ANN ARBOR HISTORIC DISTRICT COMMISSION

Staff Report

ADDRESS: 216 N. State Street, Application Number HDC17-240

APPLICATION: The applicant seeks HDC approval to remove pressed metal shingles on the mansard roof and replace them with asphalt shingles.

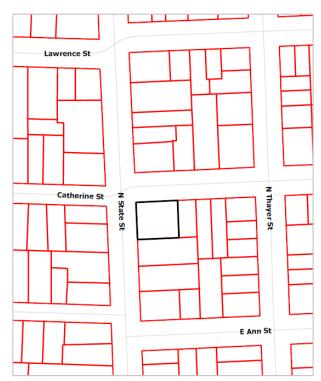
- 6. The mansard roof is a feature that strongly defines the character of this house, and is highly visible since the house is on a corner. The pressed tin roof shingles are a unique and significant decorative element that enhance the mansard roof. While the mansard roof form would remain with alternative cladding, its character would be significantly diminished because the substitution does not convey the visual appearance of the metal shingles. Staff acknowledges that the cost is substantially greater for materials compatible with the historic one; that is true of other elements of historic houses, for example, windows and sculpted block foundations.

- 7. Staff believes that replacing the tin roof with asphalt does not retain and preserve the character of the historic building and that the proposal destroys historic materials that characterize the property; the application does not meet the Secretary of the Interior's Standards number 2 and 9, nor does it meet the SOI Guidelines for Roofs, Building Site, or District/Neighborhood.
